Title:	NGP IPT Oil Check Level Plug 90-Degree Fitting			
Number:	PB_751	Release Date:	08/05/2025	
Revision Number:	Not Applicable	Revision Date:	Not Applicable	
Chassis Type:	Custom Chassis w/ NGP Pump			
Component Description:	90-degree fitting and cap			
Parts:	90-degree fitting (PN 4682600), Cap (PN 56-0234-006)

90-degree fitting and cap replacement for original NGP IPT oil check level plug.

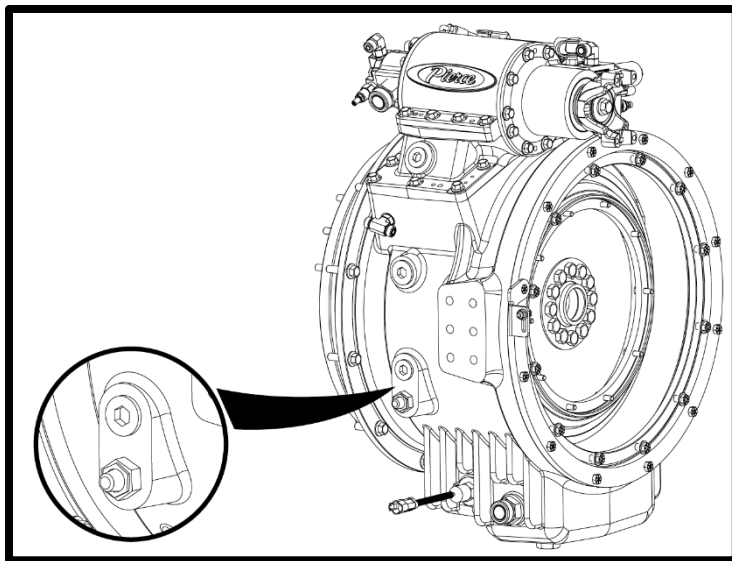
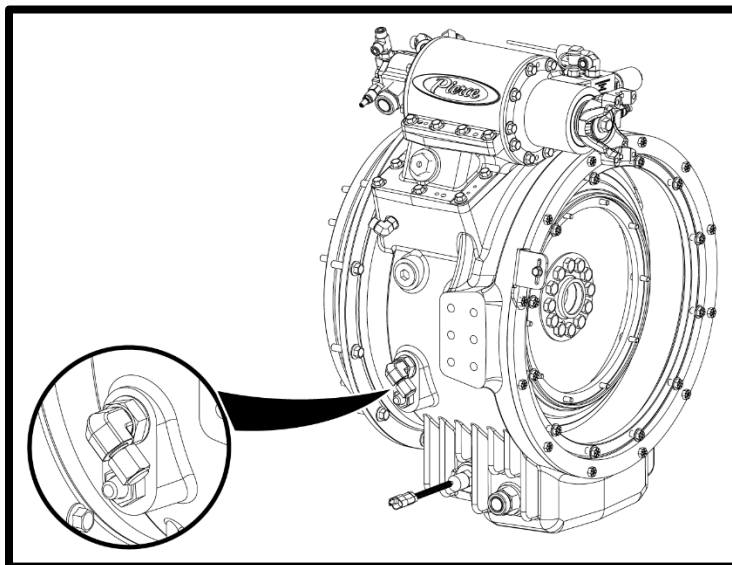
Depending on custom chassis configuration, the oil check level plug and sight glass may prove difficult to view and access on certain vehicles. Installing the 90-degree fitting and cap will allow easier access for checking fluid level while topping off the Integrated Pump Transmission (IPT) with fluid.

3. Position a suitable drain pan under oil check level plug.
4. Remove oil check level plug from IPT.

5. Lightly lubricate O-ring on 90-degree fitting (PN 4682600) with clean ATF.
6. Install 90-degree fitting on IPT.

7. Top off oil as needed by removing the oil fill plug and adding oil until fluid begins coming out of oil check level fitting.
8. Install cap (PN 56-0234-006) on 90-degree fitting.
9. Install oil fill plug.
10. Turn battery switch ON (if equipped) or connect batteries. (See "Battery Connect/Disconnect," Group 0925-P-001.)
11. Remove "DO NOT START" tag from truck ignition switch.
12. Start vehicle and let run for 2-3 minutes while checking IPT system for leaks.
13. Shut off vehicle.
